TO:
Chair
Independent Planning Commission

Harbourside Shopping Centre Redevelopment SSD-7874

POINT 1

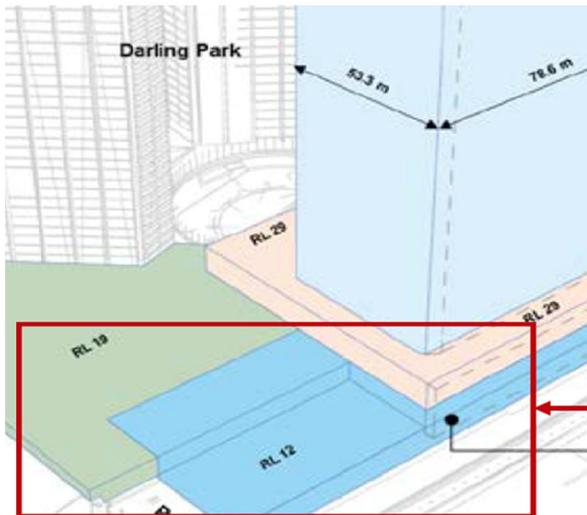
The proposed development unreasonably impacts on the surrounding area and is not commensurate in bulk and scale with neighbouring Cockle Bay redevelopment providing two inconsistent character of addressing the Cockle Bay basin as well as an inconsistent start and end of the Pymont Bridge.

RL's Cockle Bay development
RL12.00 95m from Pymont Bridge

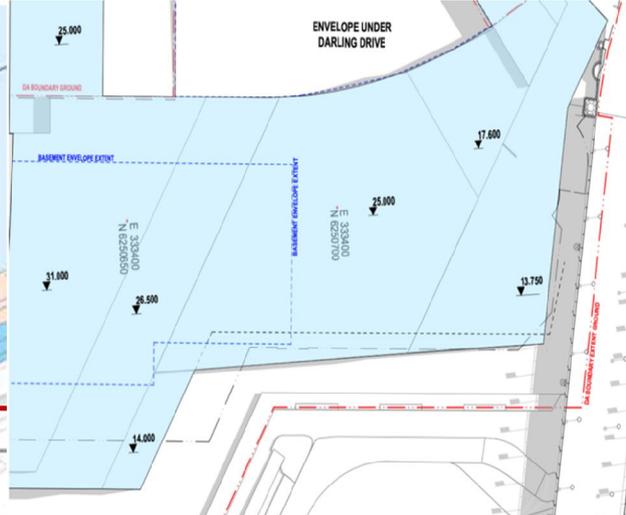
The **Cockle Bay redevelopment** has a podium with an approved RL of 12 at the harbour's edge providing a on level park some **65m** wide. This podium extends for 65m away from Pymont Bridge before increasing to RL 29 which is only 7.9m before the tower commences.

In contrast, the **Harbourside Shopping Centre Redevelopment** proposal has a podium starting at **RL of 13.75** and extends **25m** from Pymont Bridge before rising to **RL 25** for about **60m**

POINT 2

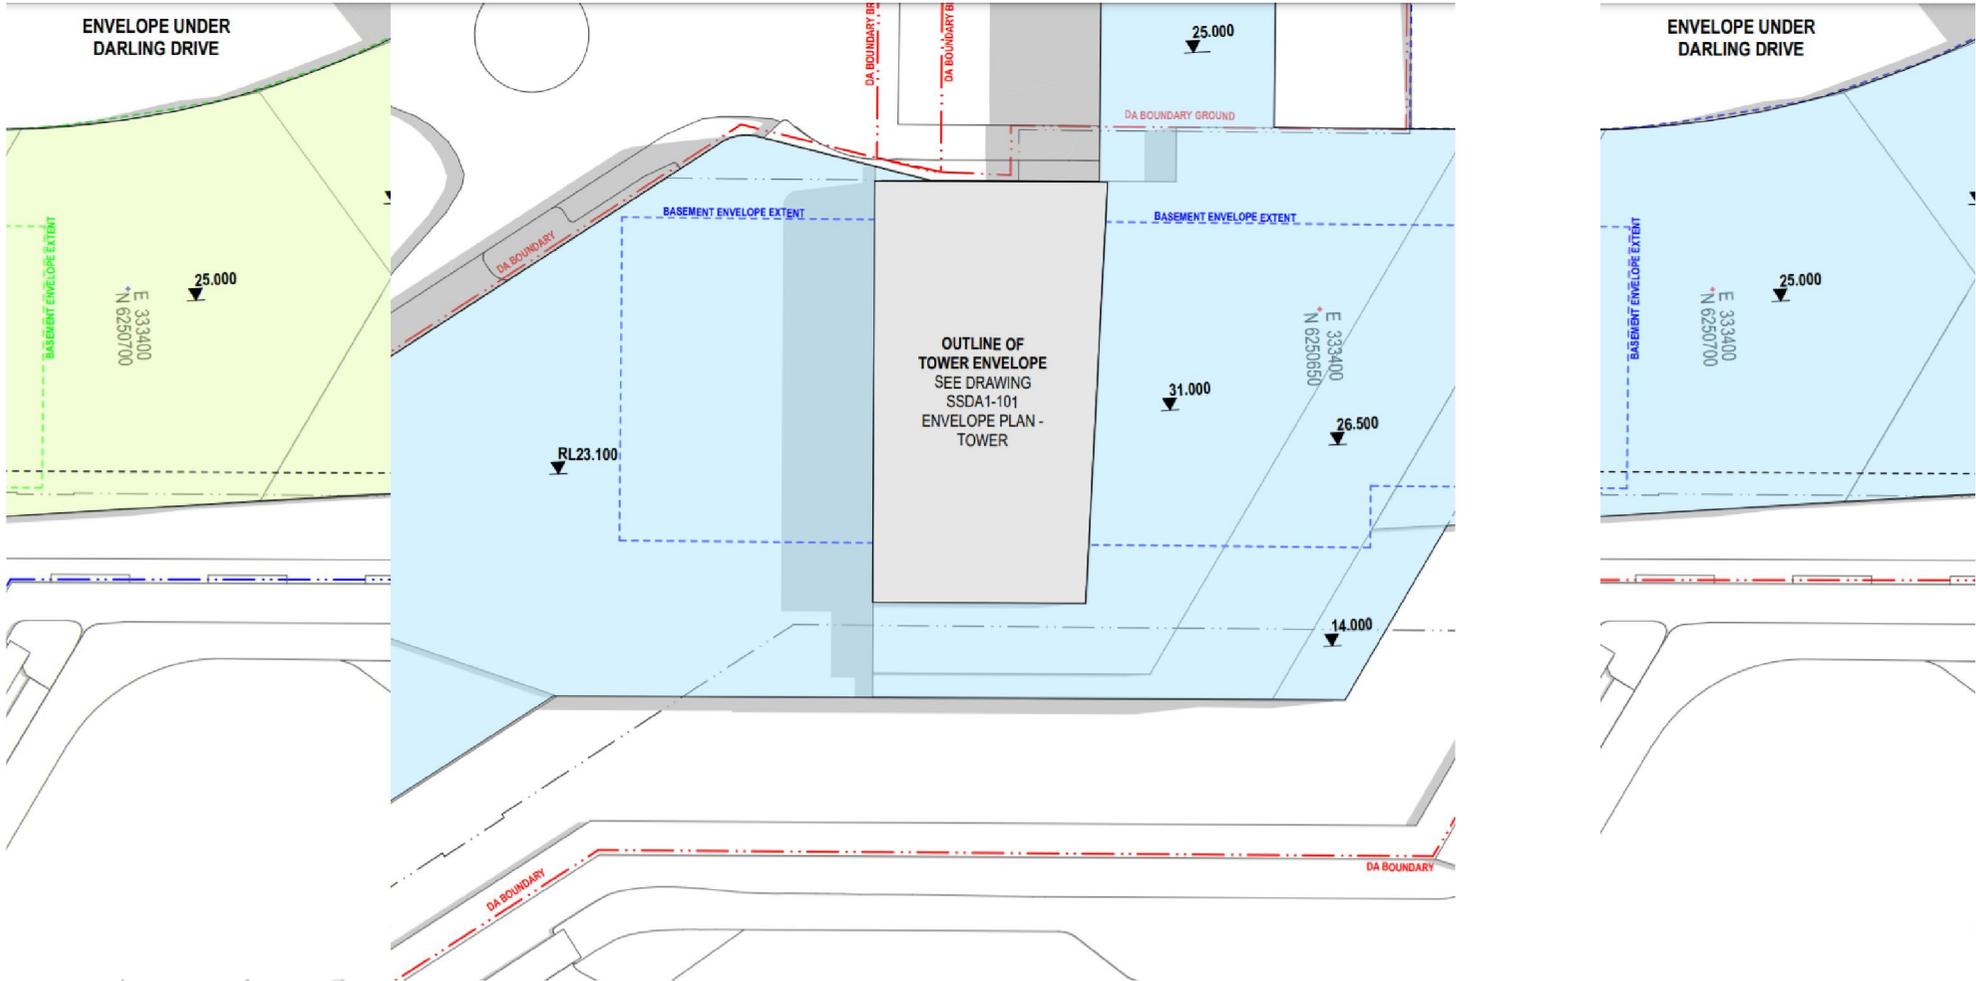
Precariously, **the southern part of the podium has the highest RL of 23.1** compared to **RL of 31.0 of the northern podium**. Therefore, southern podium even has less bulk in comparison to the northern podium closest to the State Heritage listed Pyrmont Bridge.

POINT 3

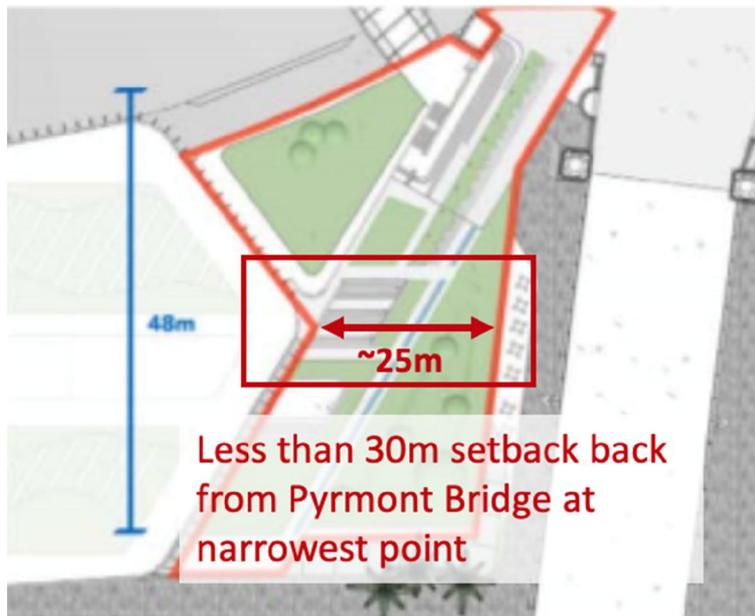
The bulk and scale of the podium at its nearest point to the State Heritage listed Pyrmont Bridge is RL 13.75 and after 25m rises to RL 26.5 or nearly twice the height of the RL of the bridge being RL 12.5. This overpowering podium is inappropriate, unsympathetic and unacceptable response to this iconic site and to the State Heritage listed Pyrmont Bridge. The Cockle Bay side of the Pyrmont Bridge has an **RL of 12 for 65 meters**. That's 65m for Cockle Bay development and only 25m for this development.

-the proposed envelope from the Pymont bridge commence with the current RL of 13.75 for 65m rising to an RL of 17.60 extending south 75m from the Pymont Bridge; and

POINT 4

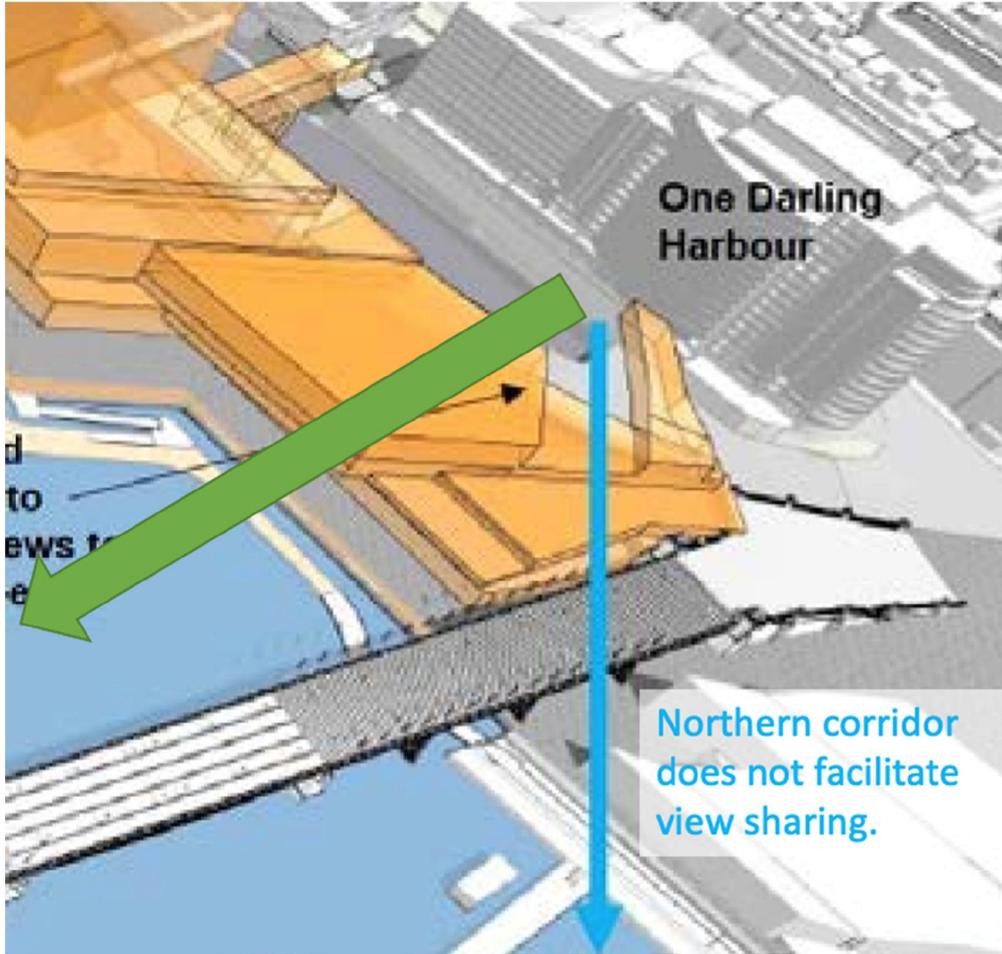
My views from One Darling Harbour over Cockle Bay (Unit 304 at One Darling Harbour) will be taken away from me by the development **for its own enjoyment**. I have views from several parts of my apartment not just at the end of the balcony viewing the waters of Cockle Bay. When it comes to **my highly valued water views**, it will not be 'view sharing' but total loss of views and I will look into what looks like a massive brick wall. The provision of a northern 'corridor' by the Applicant ignores the fact that my water views are of **Cockle Bay** and that the building is curved and you can only take advantage of the 'corridor' if you are only looking over the balcony.

Views from One Darling Harbour Unit 304 to the east

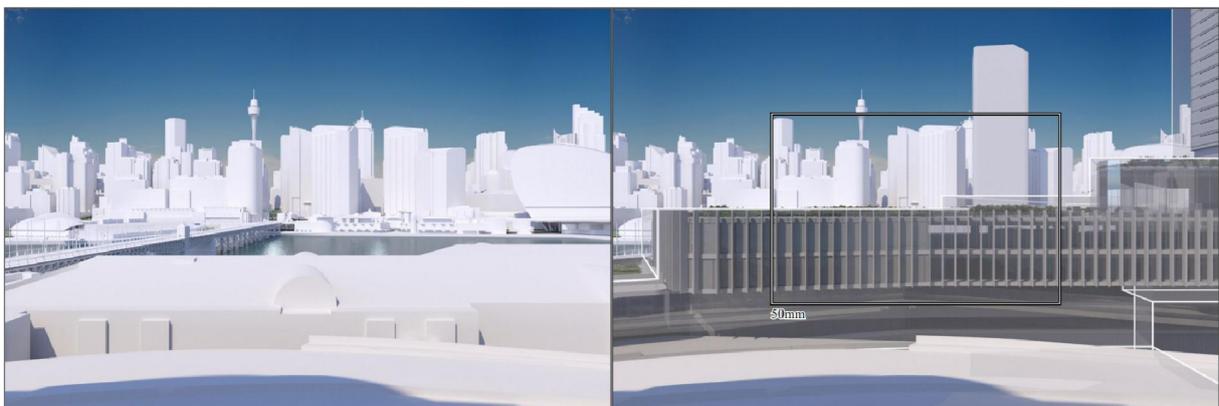
The west side of the development facing One Darling Harbour, which will replace my views of Cockle Bay, has no design element at all. It looks more like a car park façade rather than high quality design claimed both by the applicant and the Department of Planning. Not only have taken my view but replaced it with a very low amenity outlook.

Views from One Darling Harbour Unit 304 to the south/east

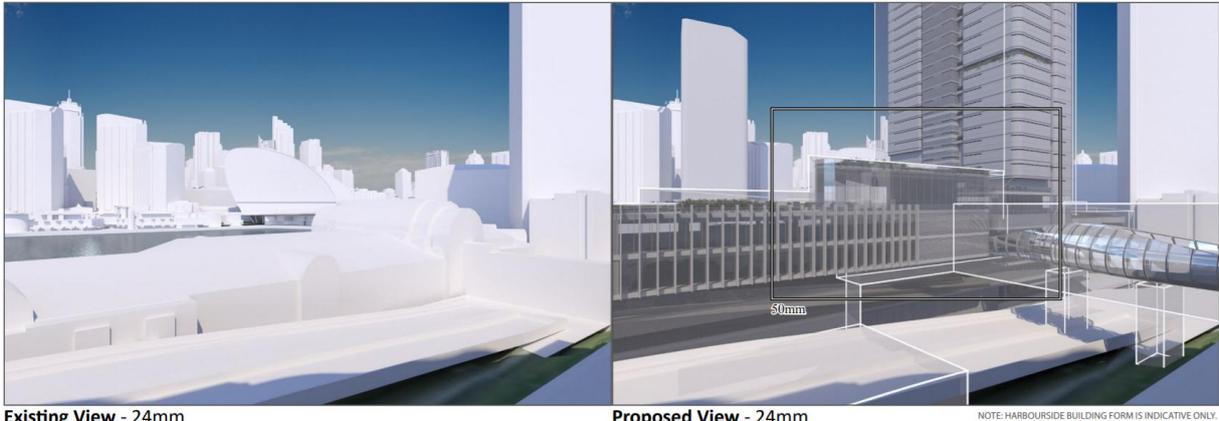
The current envelope does not include the height of landscaping or amenities which will further add to the bulk and scale of the northern podium. Trees for example can be several meters high and they should be included in the envelope as it relates to my loss of amenity by blocking my views.

- the landscaping and any proposed amenities be withing the envelope.
